AMERICAN & OHIO LOCOMOTIVE CRANE CO. INC.

OEM Product Support Bulletin

No. 37

SUBJECT: PENDANT CABLES

Figure 1: Pendant Cable with Clipped Ends
(Old Style)

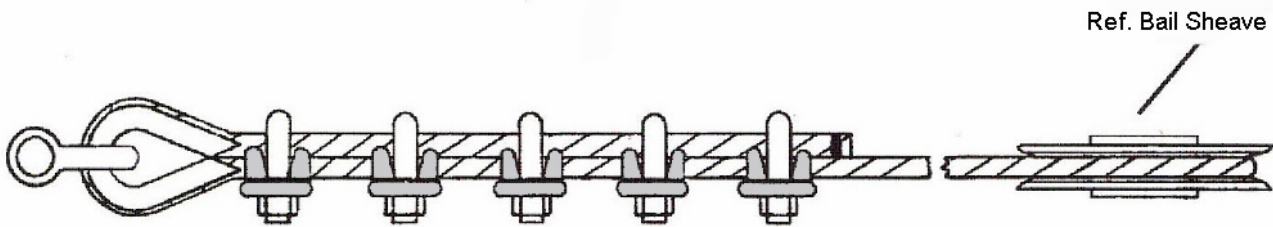
Summary: Replacement of the original Clipped Type Pendant Cables to Swaged End Type Fittings on the Pendant Cables

- Increased Strength
- Improved Fatigue and Shock Resistance
- Less Maintenance
- Easier to Install
- Certified to "OEM" Specifications
